PLANNING DEPARTMENT – Development Review Services

**RE: Albuquerque Biopark Zoo Penguin Exhibit (File: K13D034G)**  
**Grading & Drainage Plan, Engineer's Stamp Date 9-15-2016**  
**Supplemental Information, Engineer's Stamp Date 10-5-2016**

RE: **ALBUQUERQUE BIOPARK ZOO PENGUIN EXHIBIT**  
**RESPONSE TO REVIEW COMMENTS DATED September 30, 2016**

OVERALL  
GRADING AND  
DRAINAGE PLAN

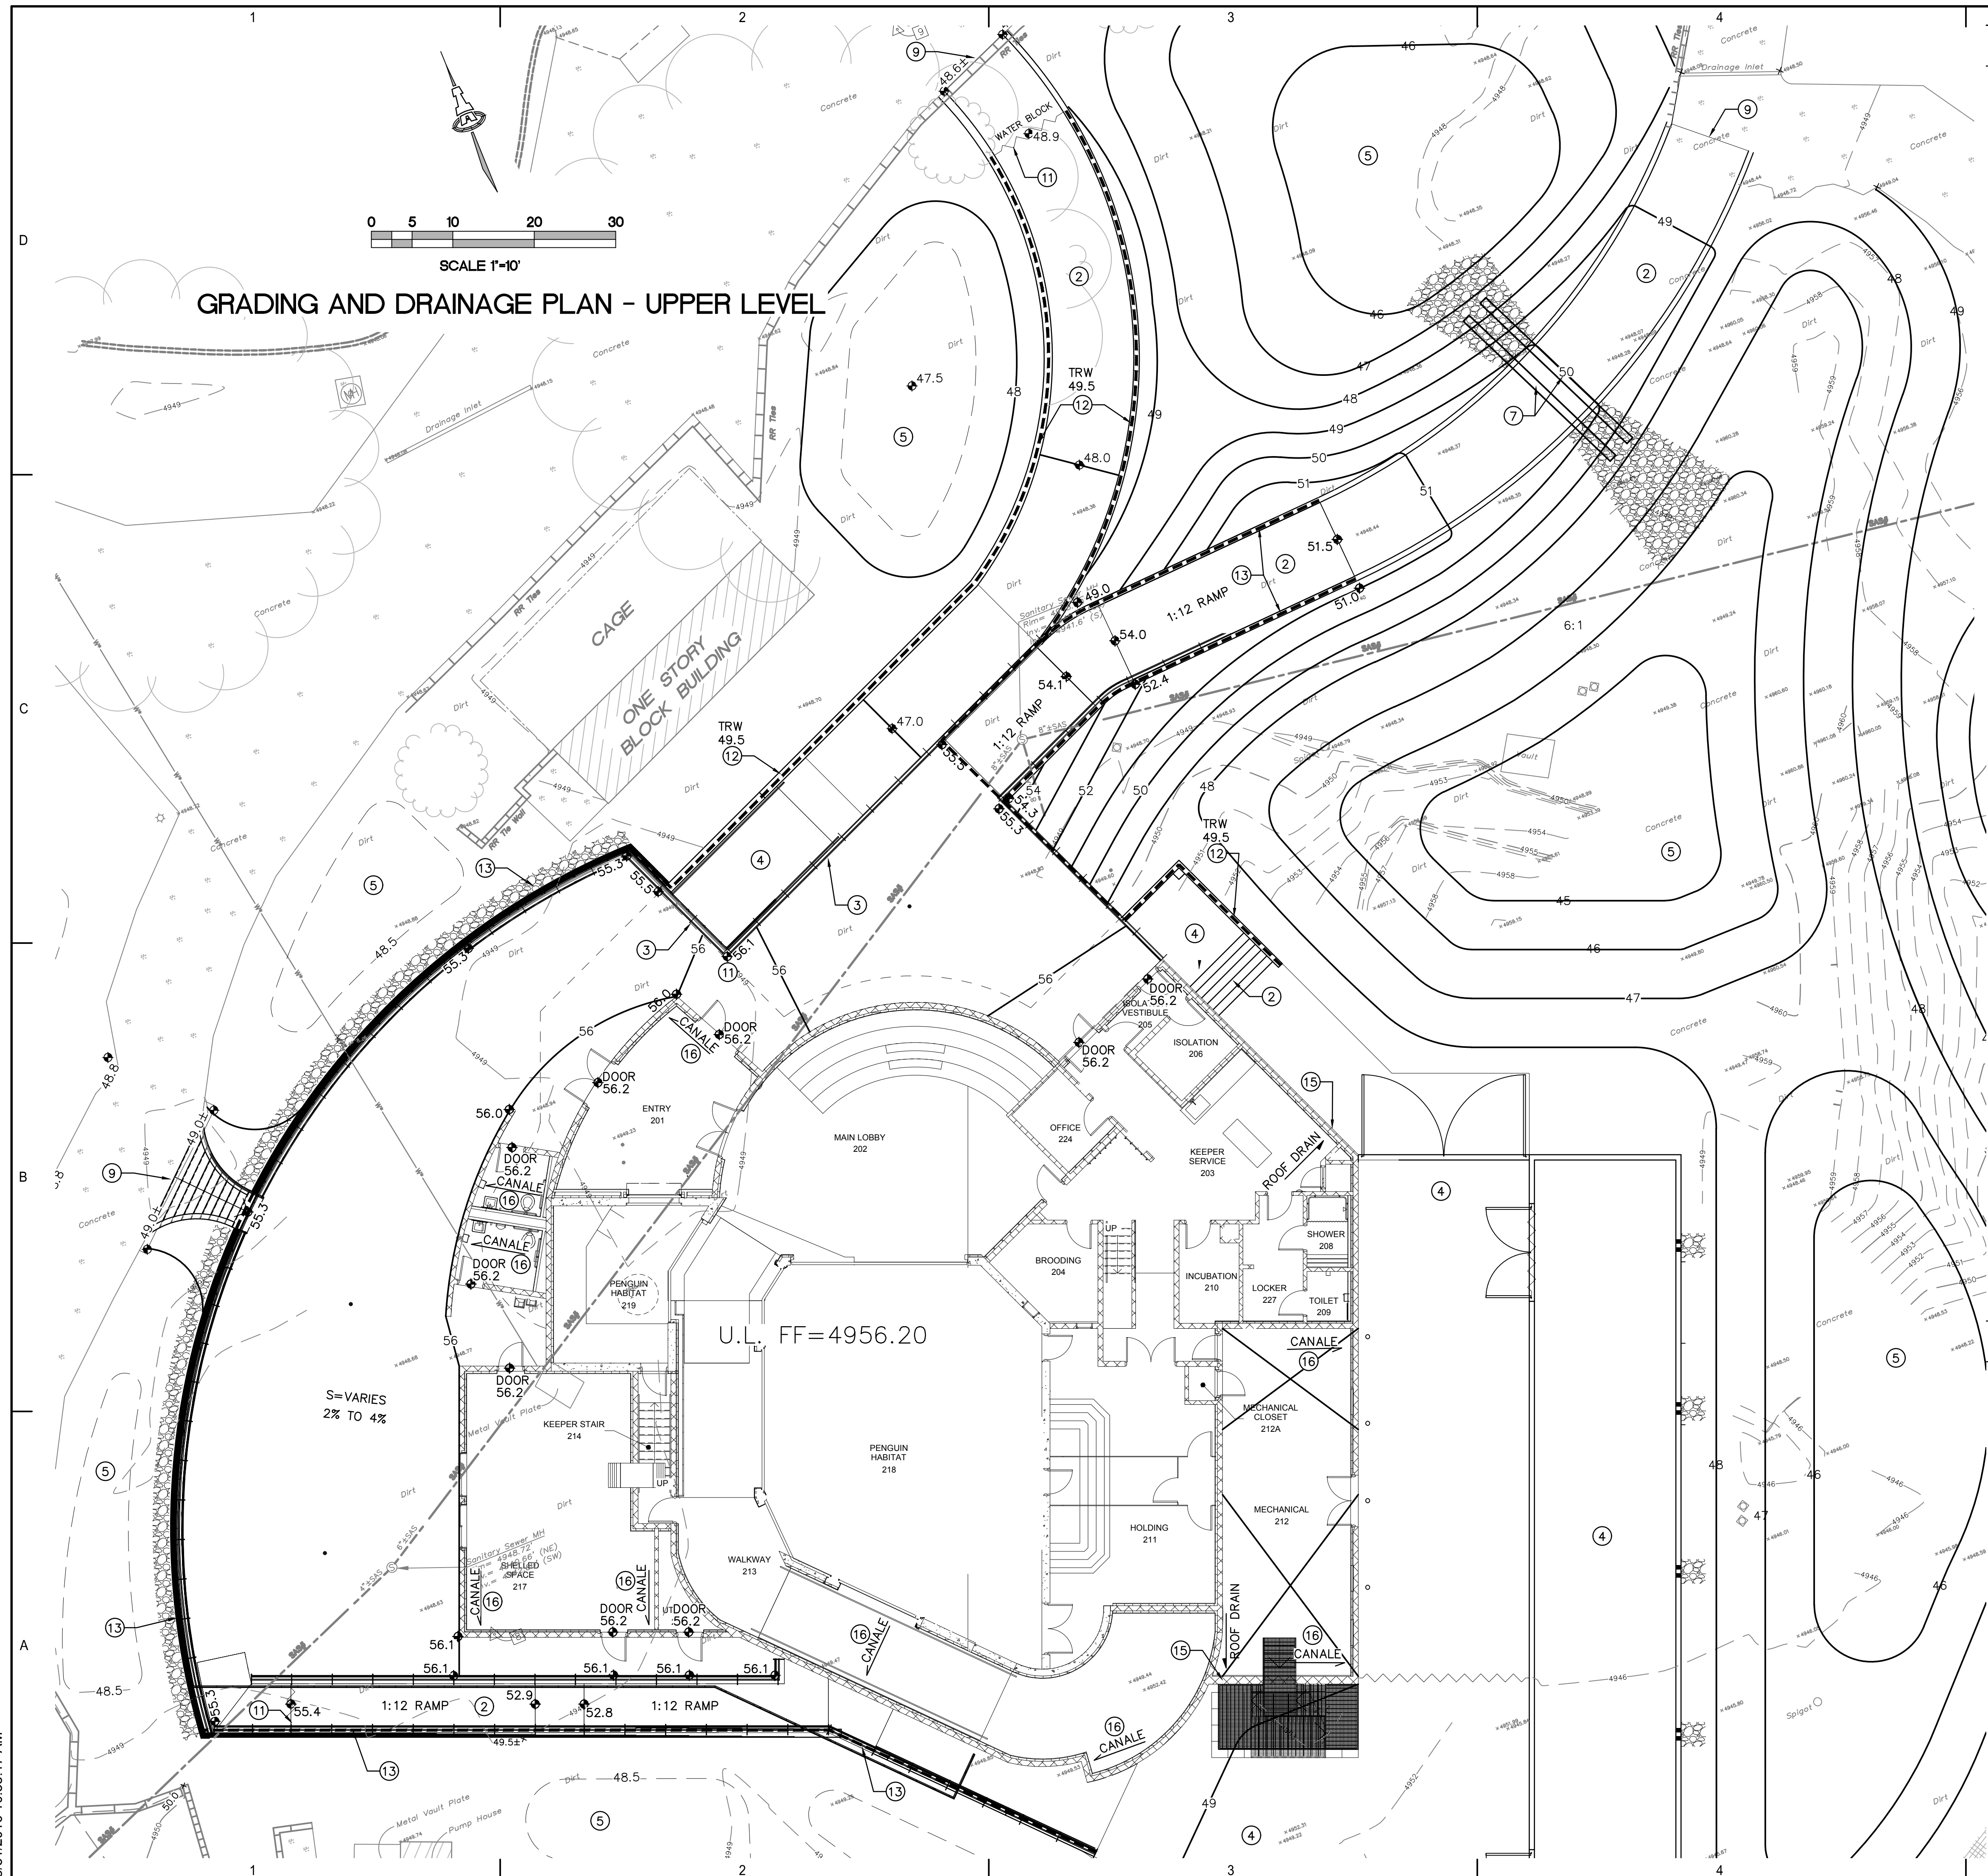
2. Regarding a maximum water surface elevation, the localized water harvesting basins will equalize via overflow elevations of 4947.5. Stormwater will continue to be retained to infiltrate into the ground until the site overflows at the historic low points (4948.4). Without a Master Drainage Study of the overall zoo drainage basins, land treatments, storm drain infrastructure and retention pond areas, a maximum water surface elevation for the main park area cannot be determined. Per conversations with Ray Johnson, Zoo Maintenance Director, they have never experienced any extensive ponding from storms.

- SEE CG-101 FOR UPPER LEVEL GRADES THIS AREA. SEE CG-102 FOR LOWER LEVEL GRADES THIS AREA.
- FINAL SITE LANDSCAPE PLAN TO BE DESIGNED UNDER SEPARATE CONTRACT. CONSTRUCT TEMPORARY WATER HARVESTING / SEDIMENT CONTROL BASINS TO ELEVATIONS SHOWN.
- OVERFLOW BETWEEN WATER HARVESTING BASINS = 47.5.
- INSTALL TWO 12" Ø CULVERTS WITH END SECTIONS. PROVIDE EROSION PROTECTION EACH END.
- GRADE THIS AREA WITH BERM (TOP OF BERM 49.0) TO PREVENT STORMWATER FROM BACKING UP INTO REPTILE AND AMPHIBIAN AREA.
- EXISTING STORMWATER FROM THIS AREA WILL CONTINUE TO DRAIN TO THE REPTILE AND AMPHIBIAN AREA.

# GRADING AND DRAINAGE PLAN MAIN LEVEL

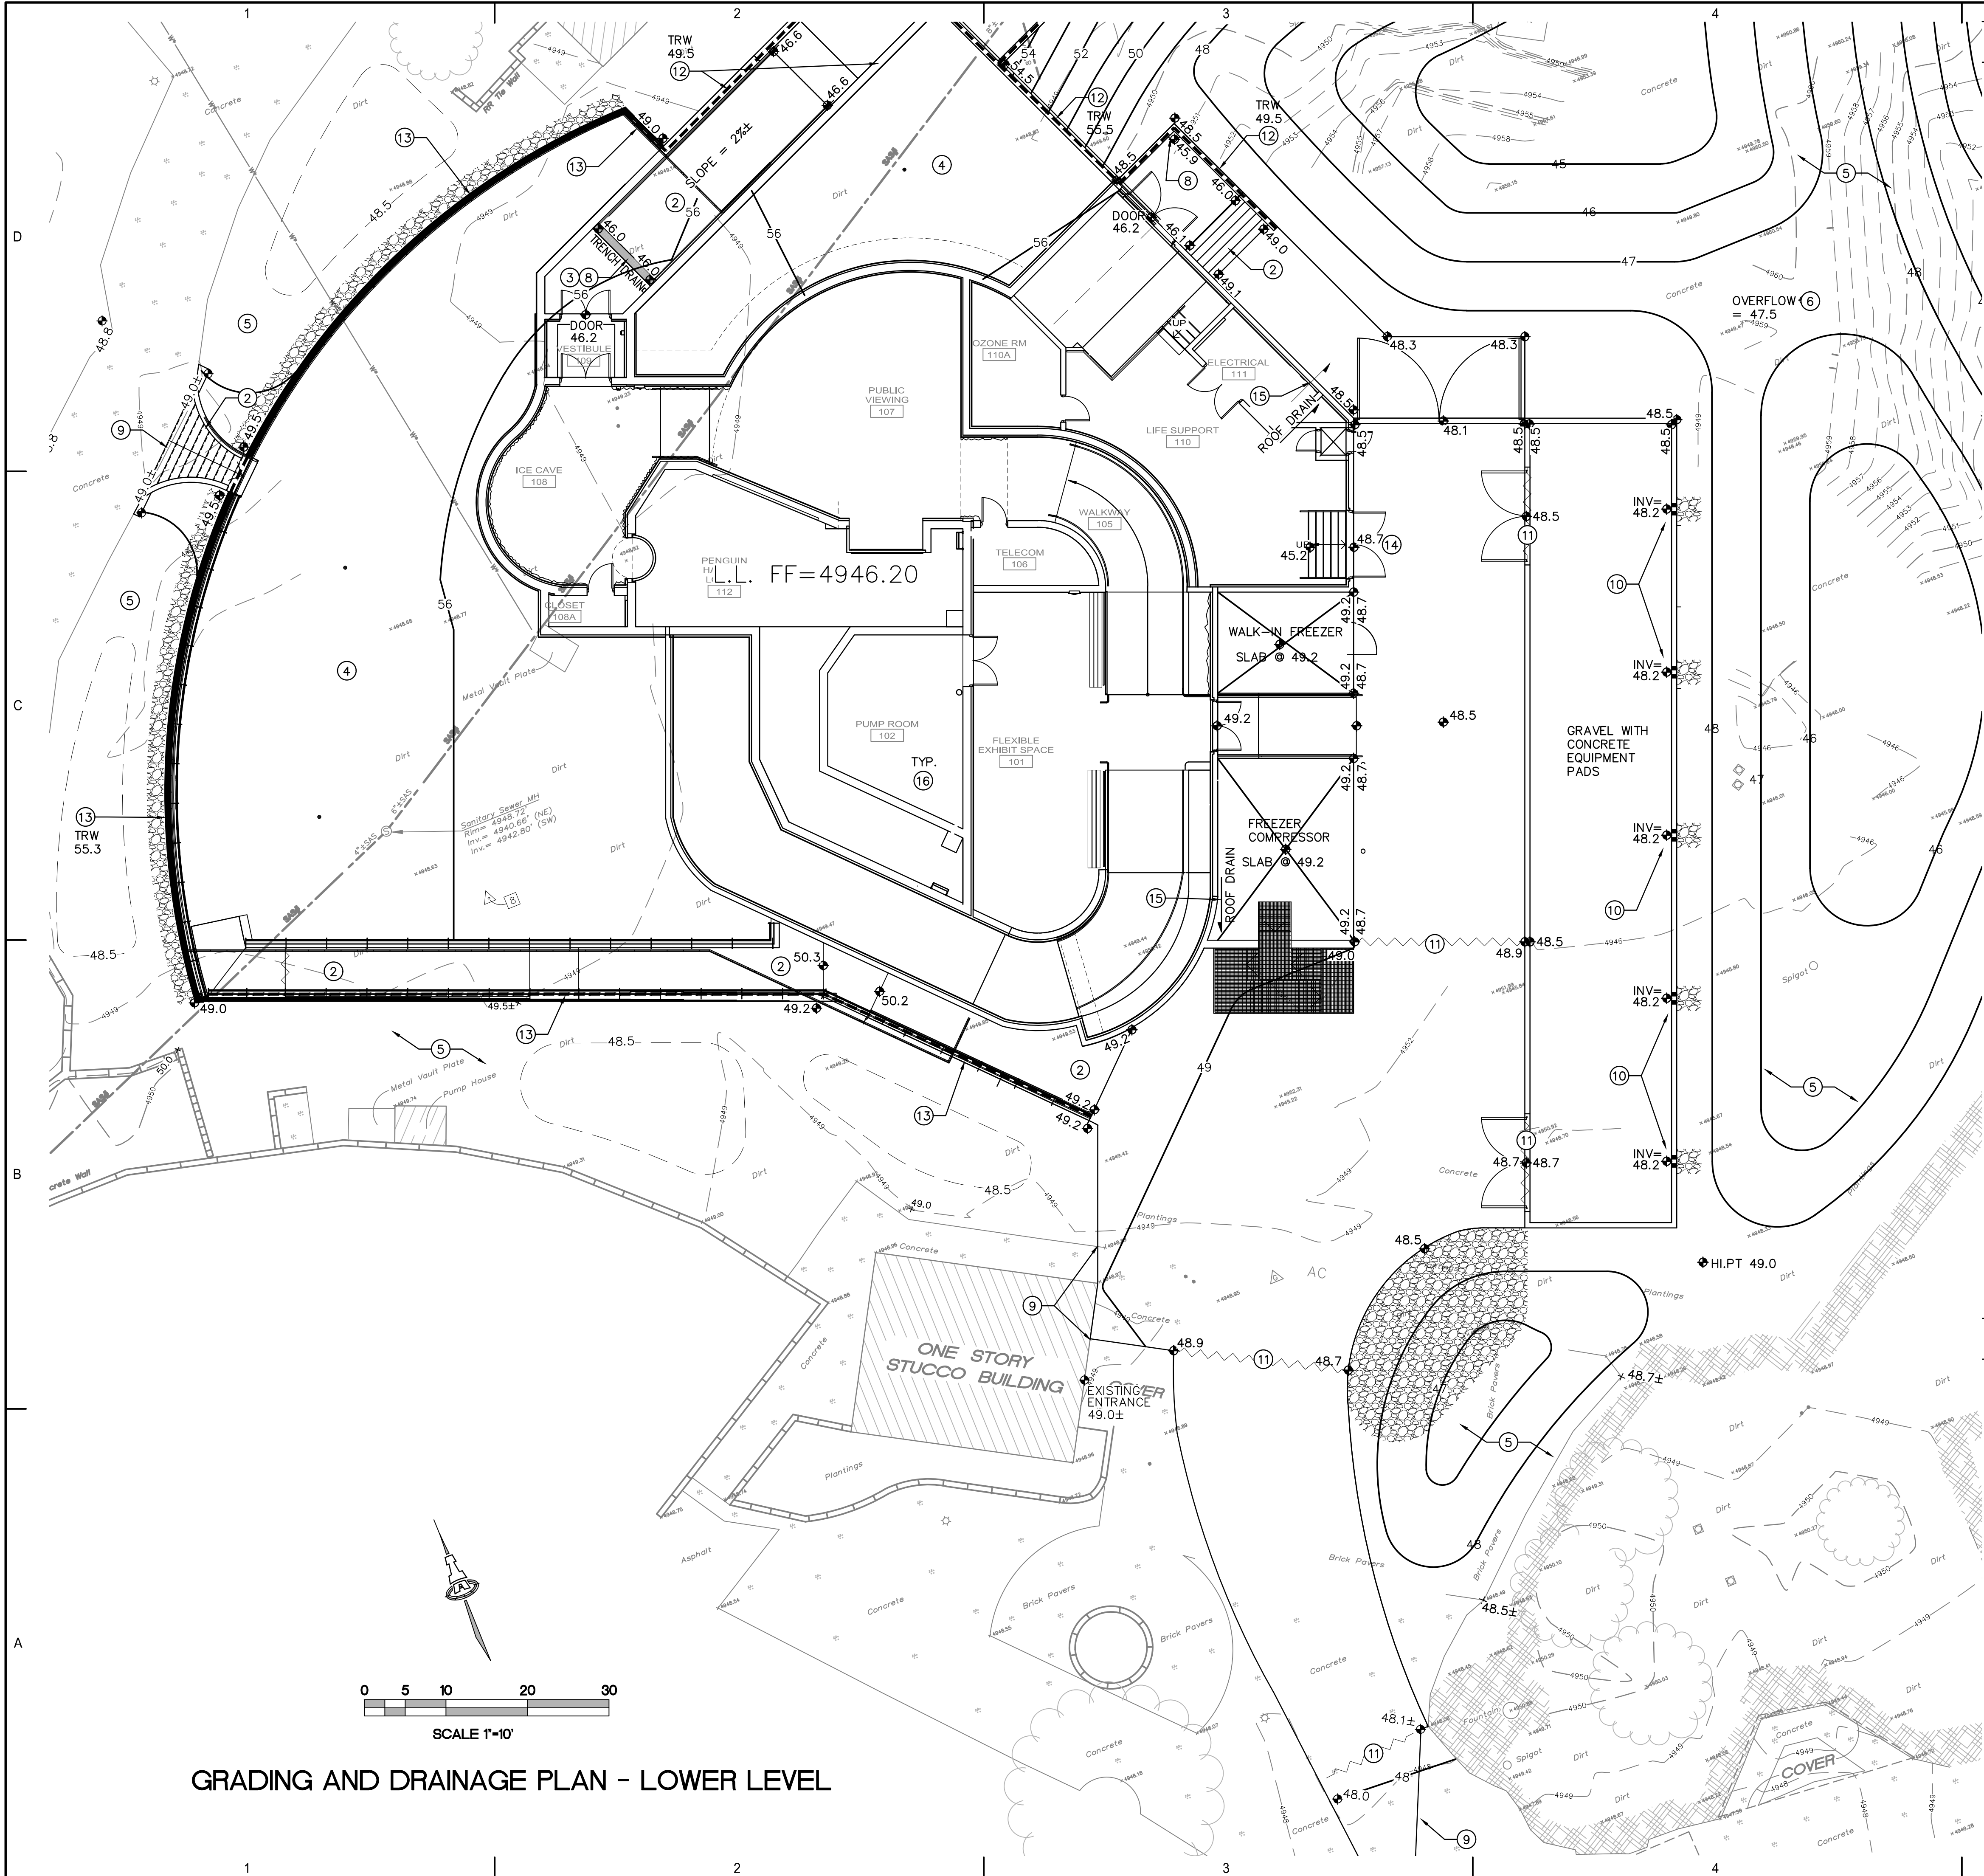
3. Elevations and keyed notes are provided on the plans to clarify the high side and low side grades of all site retaining walls. Per the architect, *"the exposed site retaining walls*

4. Regarding the drainage from the upper plaza over the retaining wall, the architect responds *"The zoo is aware that the water from the Plaza will drain over the edge and down the retaining wall masonry. The masonry units specified are designed for retention... The units have integral protection to resist staining and are made of 3000 PSI concrete."*

*will be engineered interlocking stacked masonry systems. Engineering and final detailing will be performed by the manufacturer and installer. This is specified in Section 04 22 33."*

10. NOT USED
11. PAVEMENT GRADE BREAK / WATER BLOCK.
12. CONSTRUCT BELOW GRADE SITE RETAINING WALL THIS AREA. MINIMUM TOP OF RETAINING WALL (TRW) ELEVATION SHOWN. ELEVATION AT HIGH SIDE AND LOW SIDE OF WALL ARE SHOWN ON SHEETS CG-101 AND CG-102. RETAINING WALLS EXTENDING BELOW ELEVATION 4948.5 ARE TO BE WATERPROOF. SEE ARCHITECTURAL FOR CONSTRUCTION INFORMATION.

13. CONSTRUCT ABOVE GRADE SITE RETAINING WALL THIS AREA (RETAINING BACKFILL FOR UPPER LEVEL). ELEVATION AT HIGH SIDE AND LOW SIDE OF WALL ARE SHOWN ON SHEETS CG-101 AND CG-102. SEE ARCHITECTURAL FOR CONSTRUCTION INFORMATION.
